This is to certify that BRODIE IAN B & MATTHEW A FRAHM ITS/property ownerhas permission to Single Family Home - Second floor addition w/ 2 bath and 1 bedroomAT 47 DAKOTA ST

**City of Portland, Maine - Building or Use Permit Application**

<b>Proposed Use:</b> Single Family Home - Second floor addition w/ 2nd bath and 4th bedroom	<b>Proposed Project Description:</b> Single Family Home - Second floor addition w/ 2nd bath and 4th bedroom
--	--

**PROPOSED SITE PLAN**  
SCALE: 1"=20'-0"

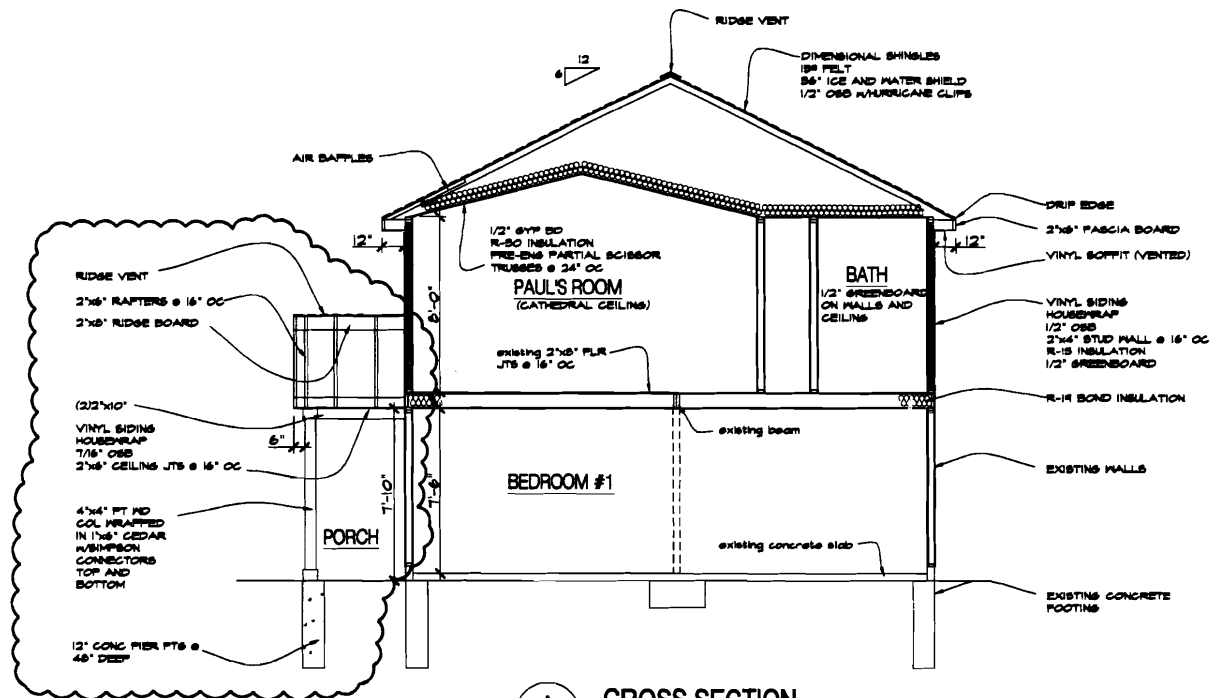
7/17/2008-mes: existing shed shown on site map is not meeting the setbacks - also the proposed new entry way is over 50 (88.7) sq ft and is only 20' from the front property line where 25' is required - will call - The 2nd floor being proposed is meeting the setbacks for the existing house. I called Ian (one of the owners) and explained the difficulty I had - He will get back to me after talking to his architect with new plans

8/11/2008-mes: 7/31/08 I received revised plans while I was on vacation - showing a covered entry way no more than 50 sq ft and 4.6' projecting from the bldg. Using 14-425 for approvals.
